CARLO GAVAZZI SPACE SpA		CERN MIT L3 A&C/AMS <b>AMS02-PDS</b>			Doc.N°: NCR-PDS-CGS-C-132 Rev.: 1 Date: 18/03/09 Page 1 of 5 attach: Annex A, B, C, D	
		<b>NON CONFORMANCE REPORT</b>				
2 NCR Title: PDS input current telemetry						
IDENTIFICATION	3 Supplier	4 Purchase Order N°	5 Model	6 Subsystem	7 Procedure/Work Item N°	
	CGS	N.A.	PFM	N.A.	N.A.	
	8 NC ITEM Identification	9 Drawing N° Rev.	10 P.N. / C.I. N°	11 Serial N°		
	AMS02 Power Distribution System Assembly	10-AMS02PDS-000.00 /	10-AMS02PDS-000.00 / PDS18	FM01		
DESCRIPTION	12 Next Higher Unit Id.	13 Drawing N° Rev.	14 P.N. / C.I. N°	15 Serial N°		
	NA	NA	NA	NA		
	16 NON CONFORMANCE Detected During: RECEIVING INSP. <input type="checkbox"/> MANUFACT. <input type="checkbox"/> ASSEMBLY/INTEGRATION <input type="checkbox"/> FINAL INSPECTION <input type="checkbox"/> TEST <input checked="" type="checkbox"/> OTHER <input type="checkbox"/>					
	17 Initiator, Dept., Date, Signature A. Albarin, Technical directorate, 18/03/09

Doc.N°: NCR-PDS-CGS-C-132

Tab. 2: Section B TRP=-25°C input current telemetry verification

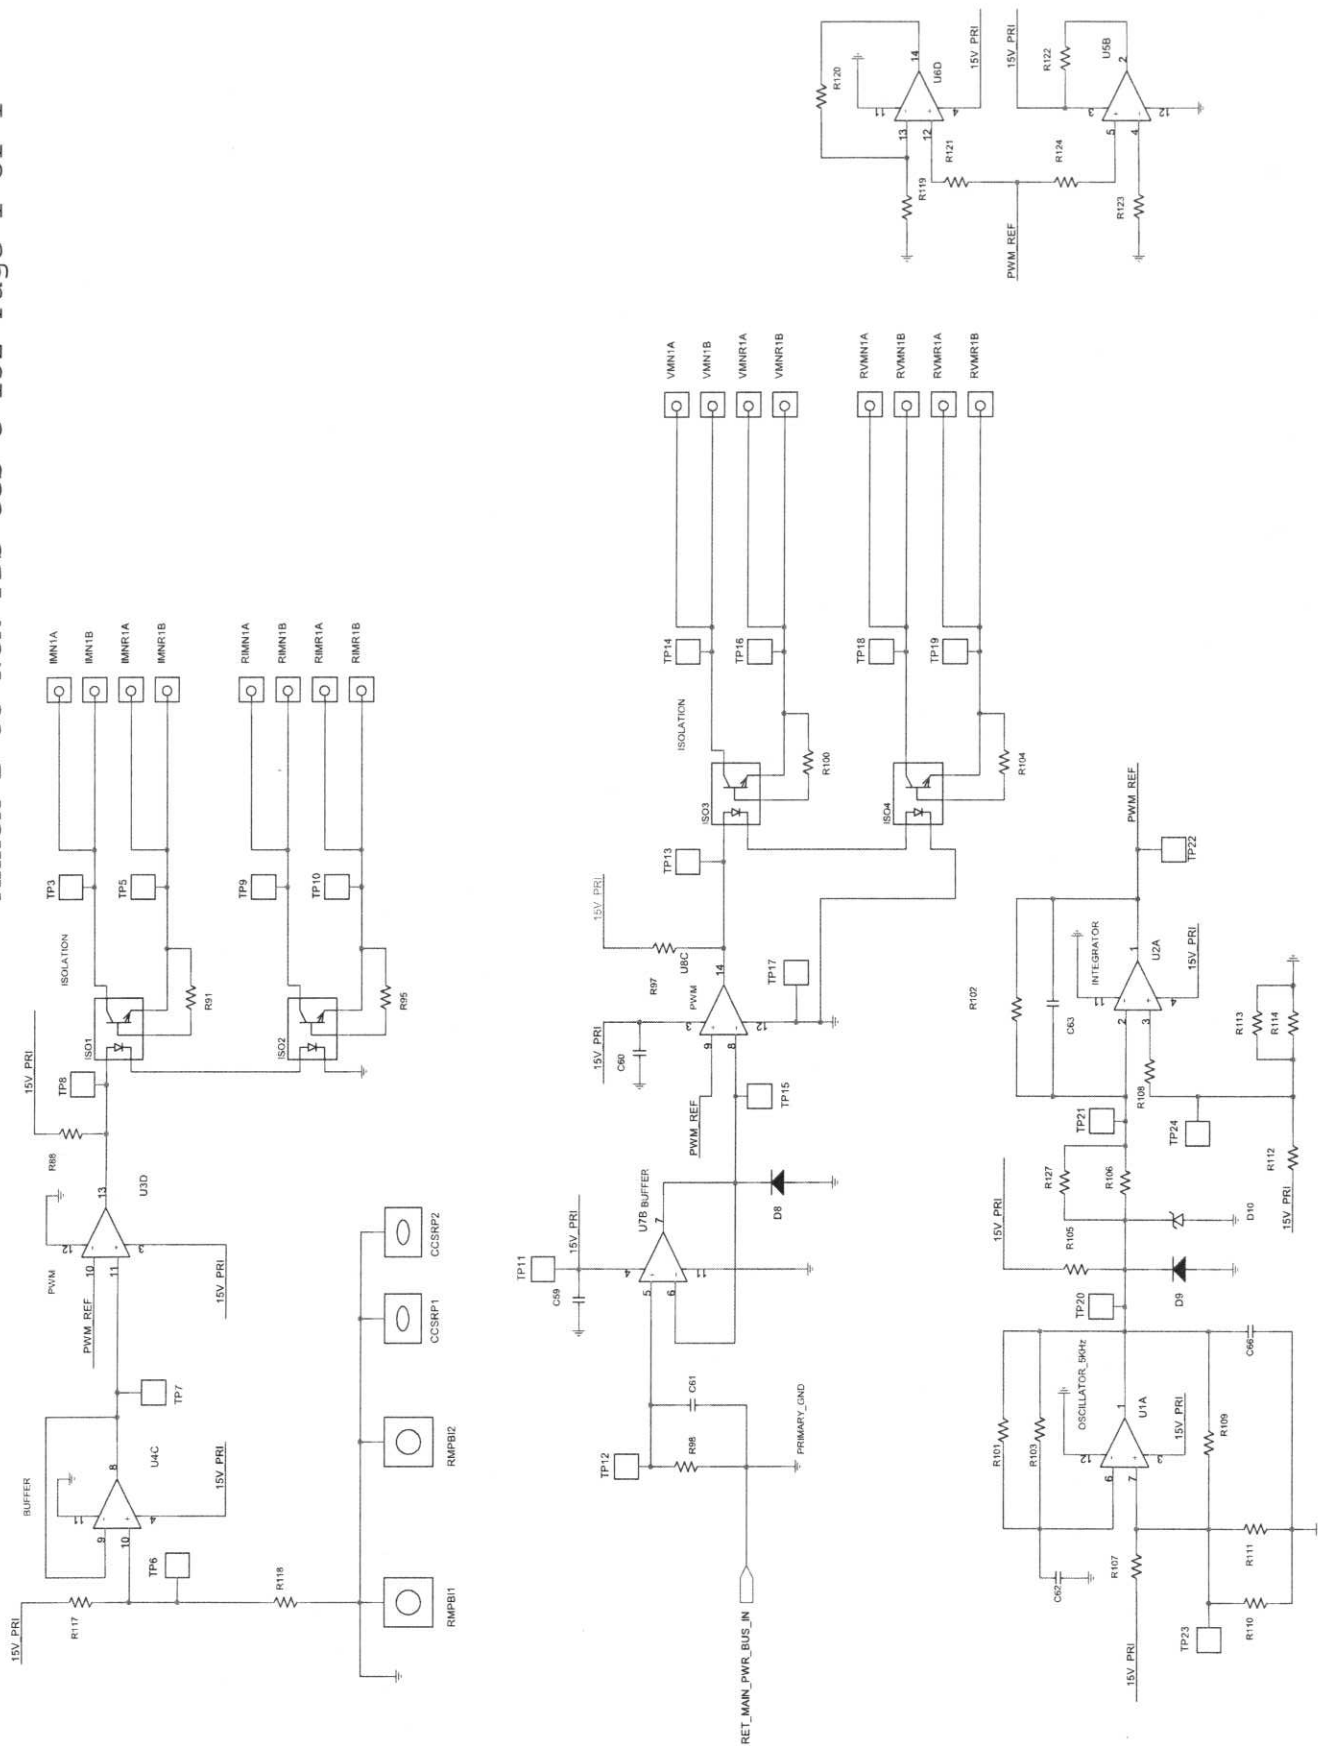
INTERNAL NRB DISPOSITIONS	18 Description of NON CONFORMANCE During reduced thermal test foreseen by NCR-PDS-CGS-C-129, the following problems have been observed at -25°C unit temperature: • the input current telemetry reaches the saturation. See columns CAN BUS 30 telemetry [A] and CAN BUS 31 telemetry [A] of tables contained in Annex A. • The telemetry tolerance exceeds the 5% full scale value. See columns CAN BUS 30 Full scale error [%] and CAN BUS 31 Full scale error [%] of tables contained in Annex A.					
	19 Requirements violated AMS-RQ-CGS-002 Is.1 Par: 3.2.2.3.1					
	20 INTERNAL NRB Dispositions: See next page					
	21 Verifications					
INTERNAL NRB DISPOSITIONS	22 Suspected cause of NC: HANDLING <input type="checkbox"/> TRANSPORTATION <input type="checkbox"/> TEST EQUIPMENT <input type="checkbox"/> TOOLS <input type="checkbox"/> SW <input type="checkbox"/> DESIGN <input checked="" type="checkbox"/> OPERATOR/PROCEDURE ERROR <input type="checkbox"/> PART <input type="checkbox"/> MATERIAL <input type="checkbox"/> PROCESS <input type="checkbox"/> TEST <input type="checkbox"/> OTHER <input type="checkbox"/>

In order to avoid the saturation effect at low temperature (e.g. -25°C), the full scale current value shall be set to 33A.
